**Origination Form**  
 Proposed Revisions to a Standard Plans Index

<b>Originator:</b>	Gibbs, Shae	<b>Index Number:</b>	711-003
<b>Date:</b>	5/5/2025	<b>Sheet Number(s):</b>	2,5,6,7
<b>E-mail:</b>	shae.gibbs@dot.state.fl.us	<b>Index Title:</b>	Interchange Markings

**Summary of the changes:**

TYPICAL INTERSECTION

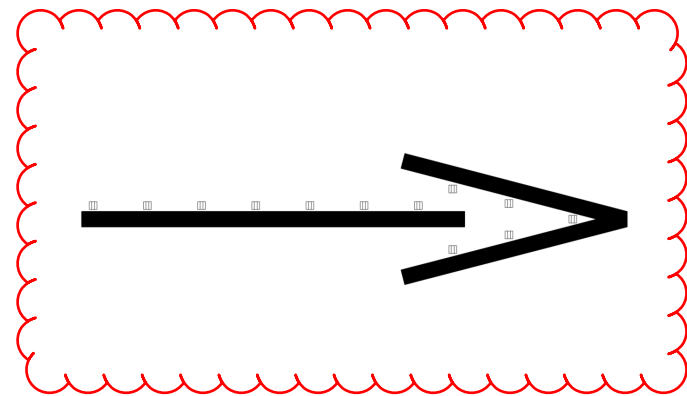
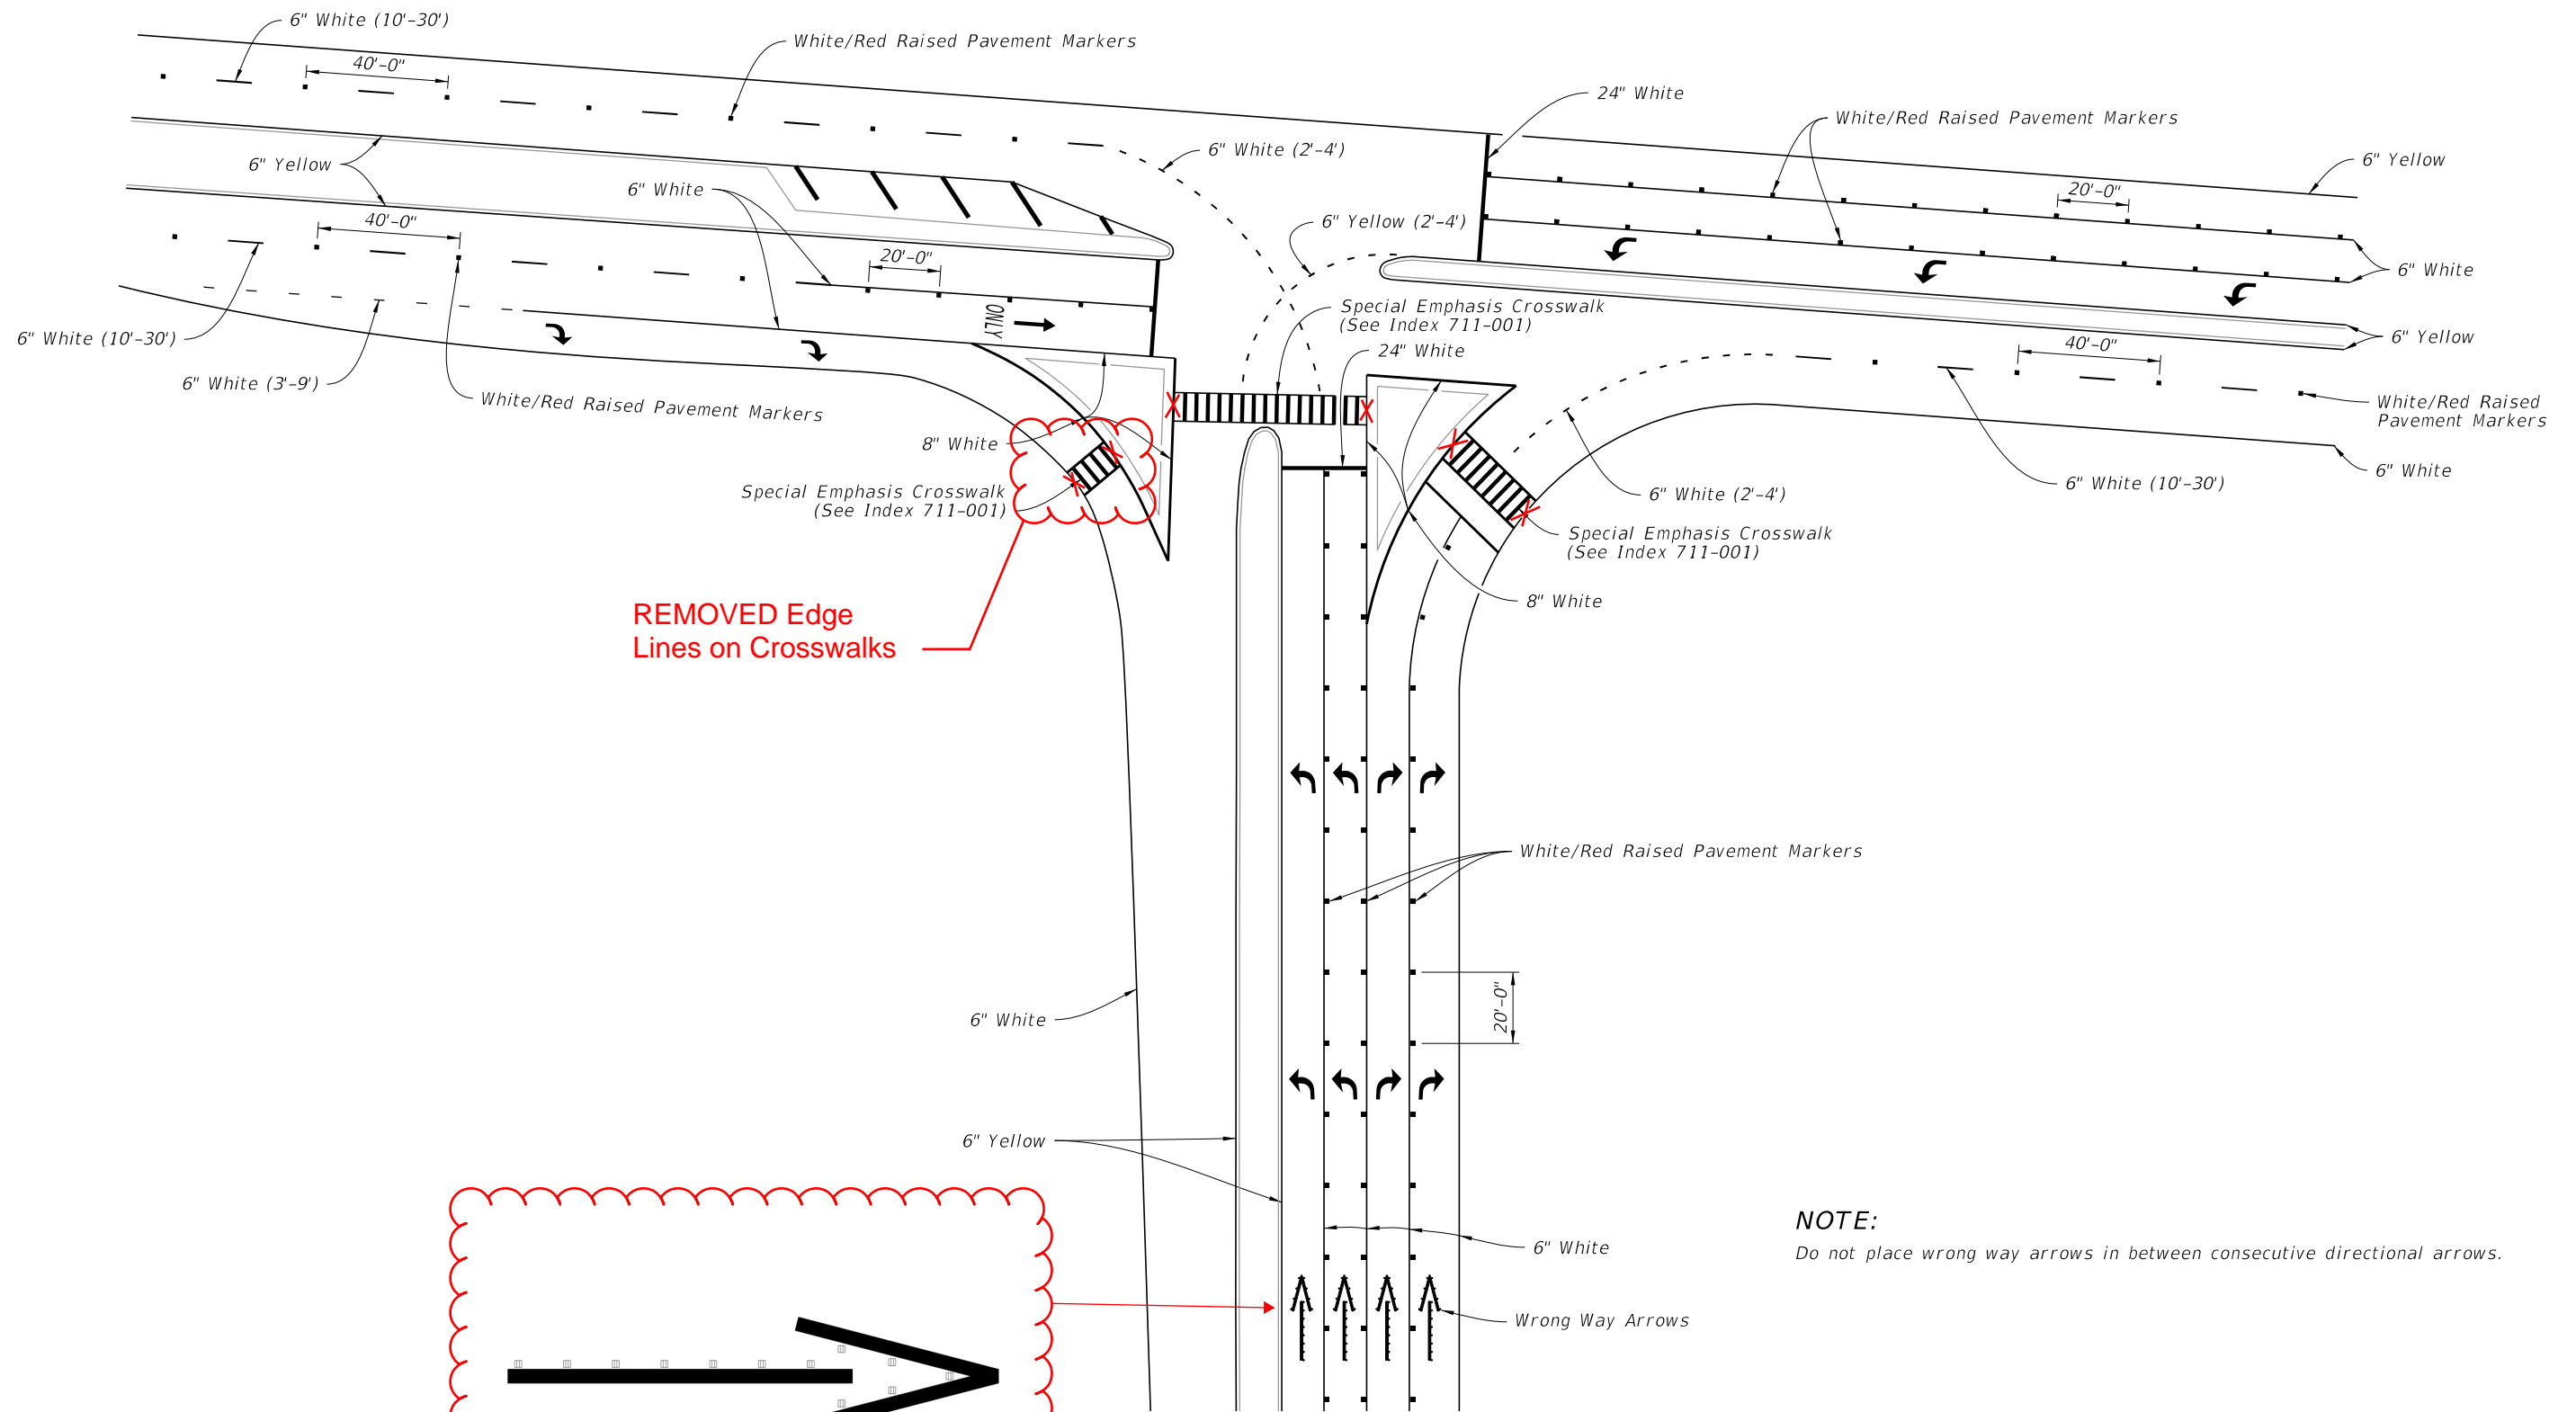
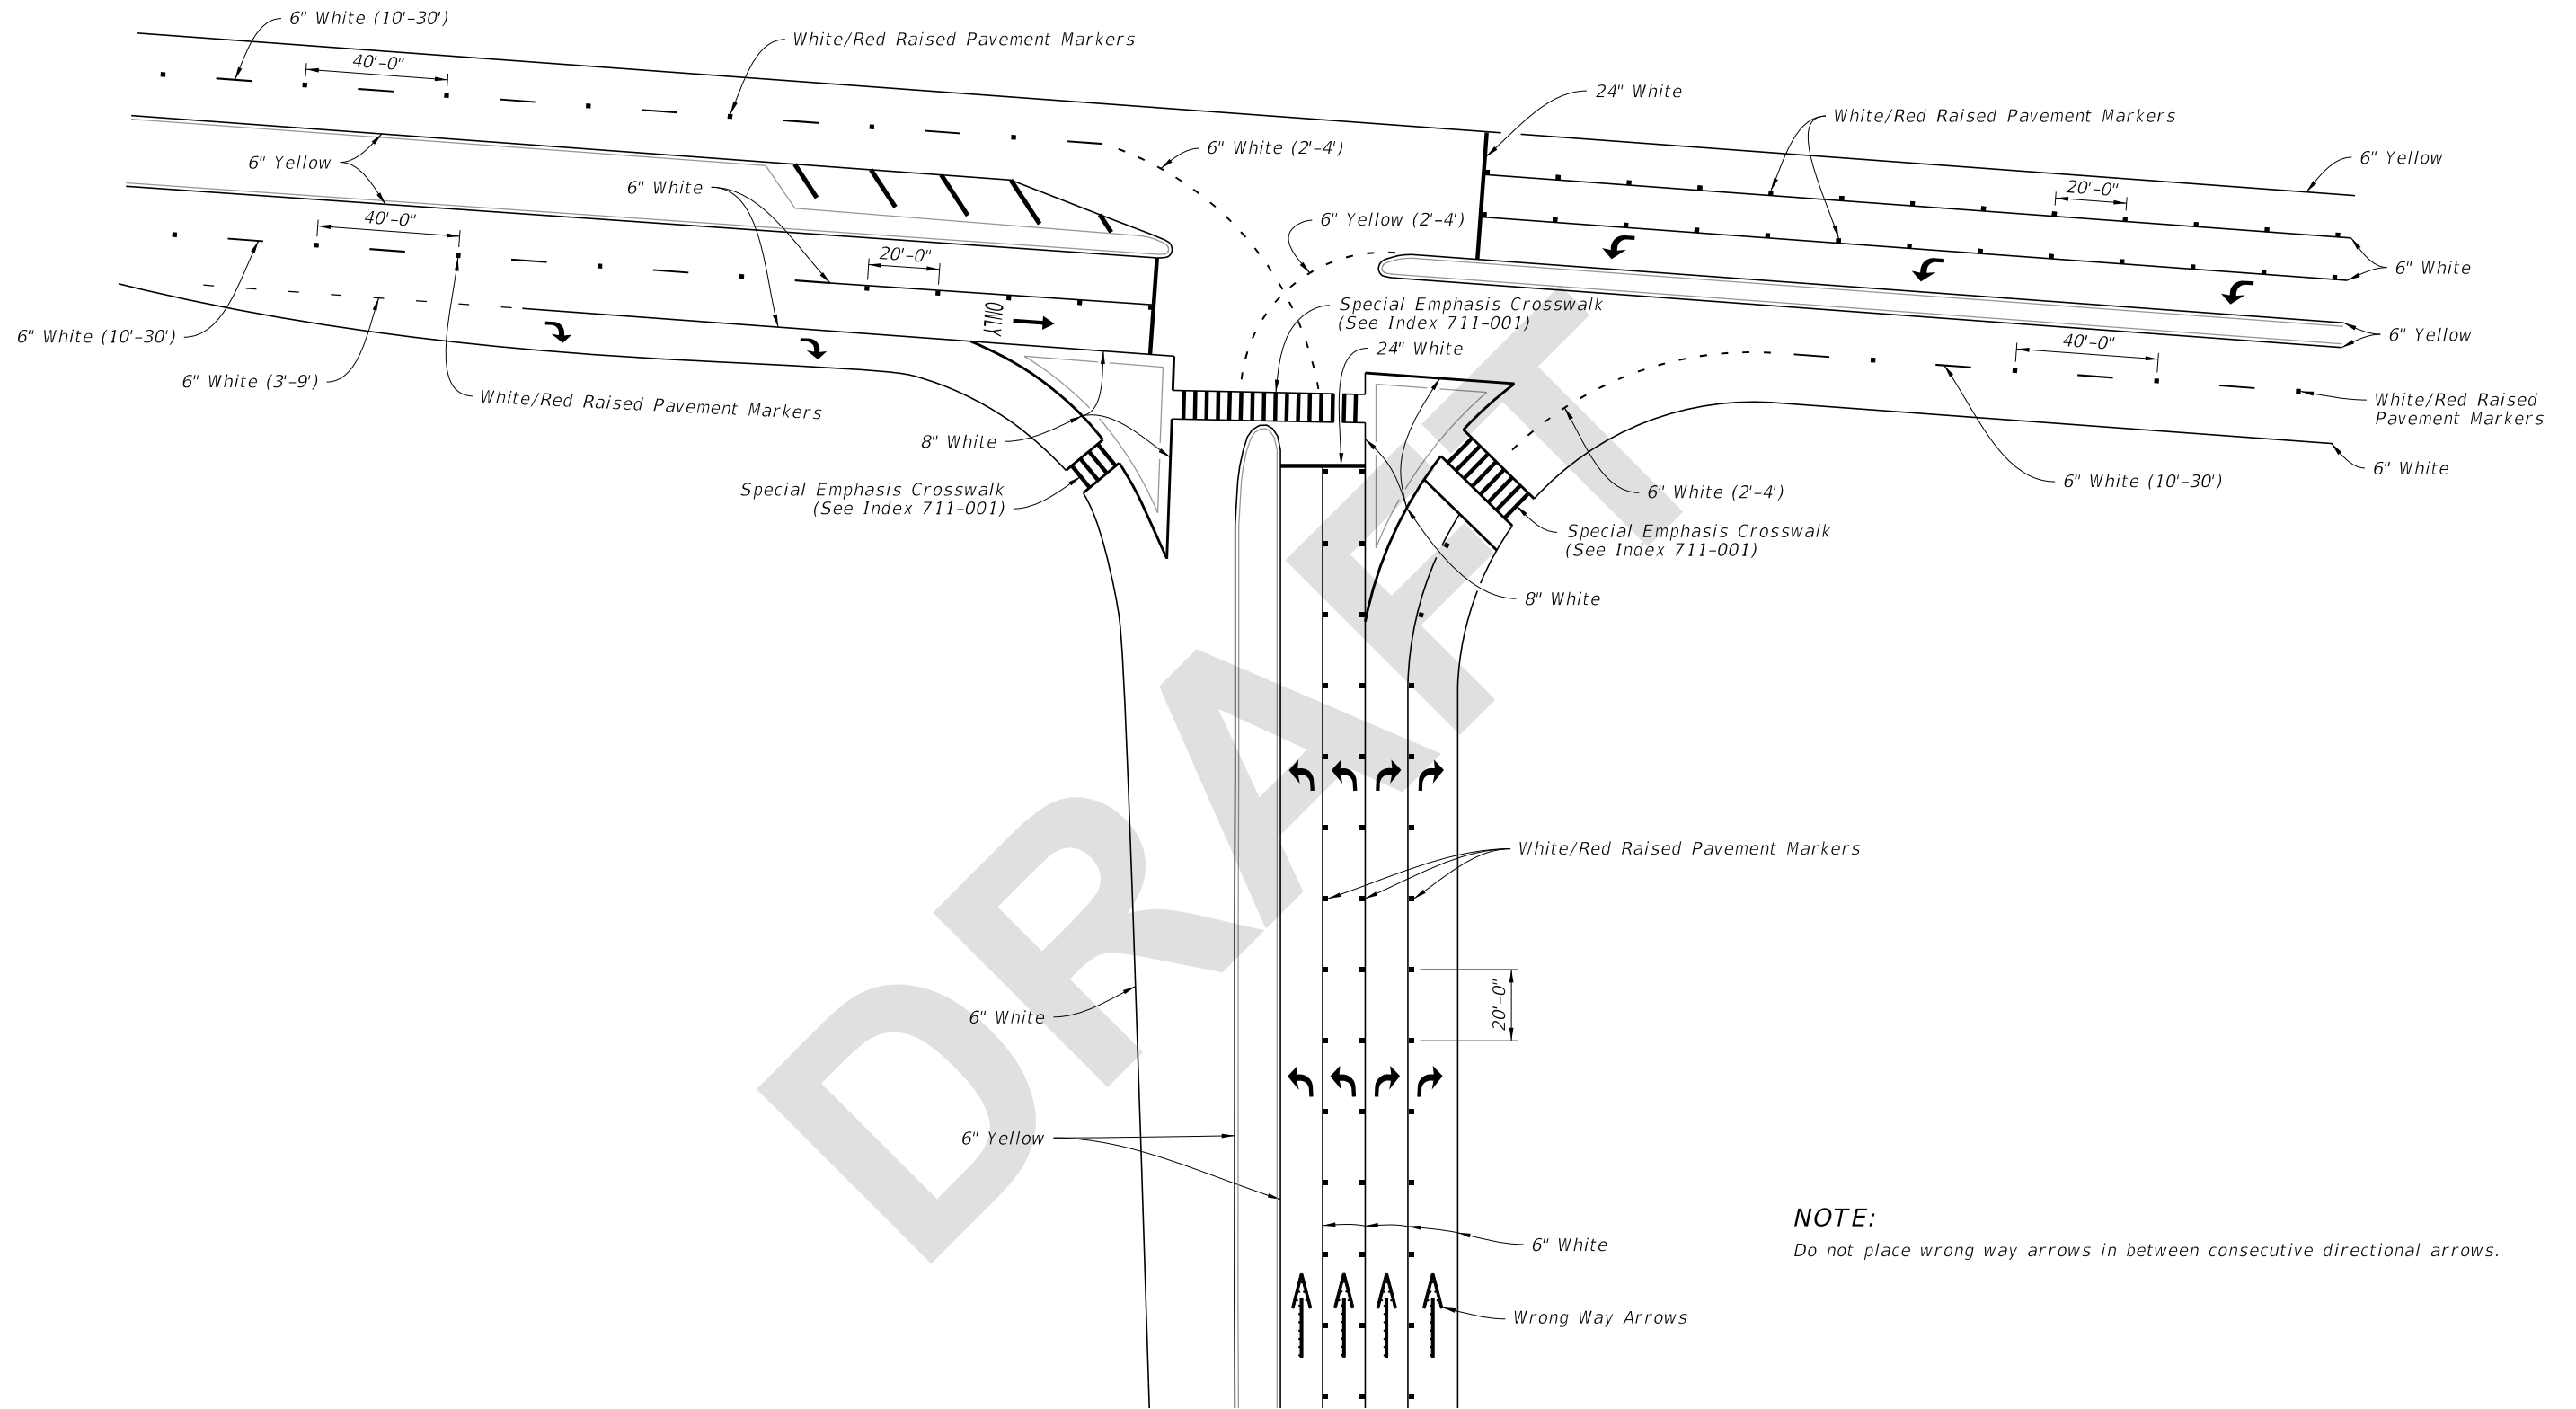
UPDATED Wrong Way Arrows to  
remove extra RPMs per 706-001  
revision
